# **Report on New Circumstances Related to the Environmental and Social Impact Assessment (ESIA) of the Amulsar Gold Project in Armenia**

**Balkani Wildlife Society, Bulgaria**

**November 2018**

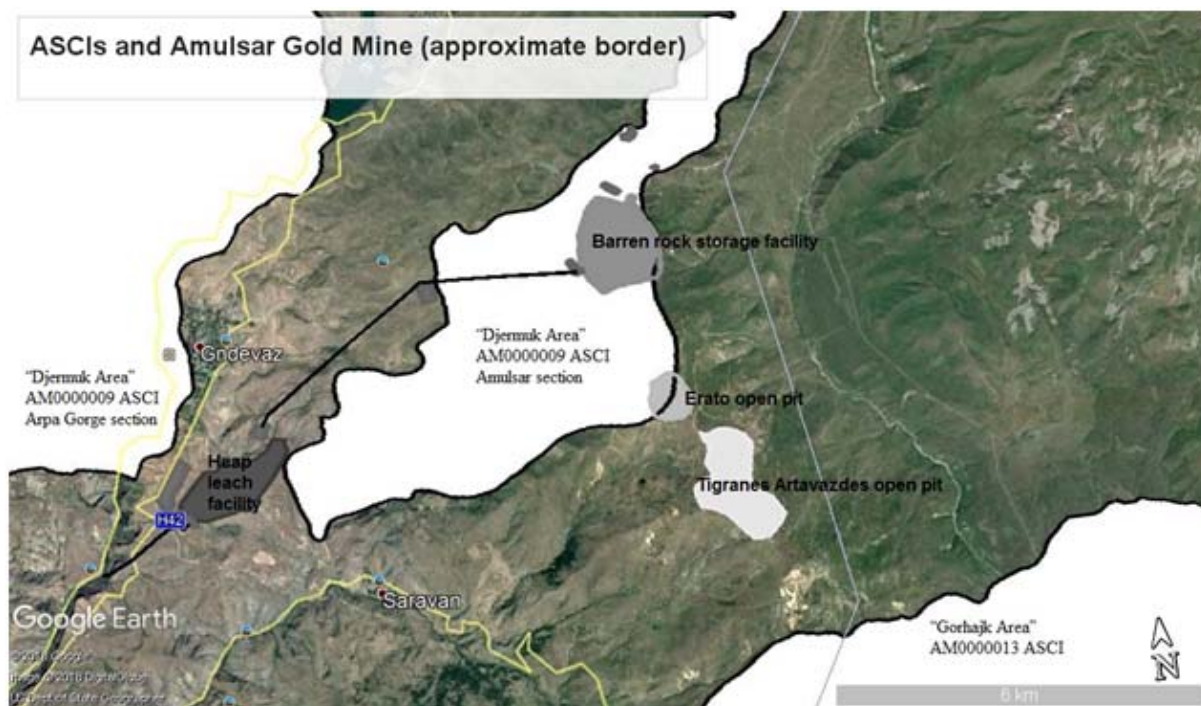
After comparing borders of ASCIs and the planned Amulsar Gold Project as proposed in the Environmental and Social Impact Assessment (ESIA) report from May 17, 2016<sup>8</sup> (see schematic map below) we established that:

- **Significant part of the planned Amulsar Gold Project is inside the territory of the “Djermuk Area” AM0000009 ASCI.** More particularly inside this territory are the following parts of the gold mine project: barren rock storage facility, Erato open pit mine, transportation line/facility. The heap leach facility (HLF) is situated in the immediate vicinity of the “Djermuk Area” AM0000009 ASCI at 50-650 m from the Amulsar section of the site and at 250-550 m from the Arpa Gorge section of the site;
- The open pit, storage, transportation and processing facilities of Amulsar project and the “Gorhajok Area” AM0000013 ASCI are not overlapping, but the distance between them is 1550 – 2000 m and negative impacts should not be excluded. Southern part of Amulsar Gold Project (set-aside area) is

partially within “Gorhajn Area”.
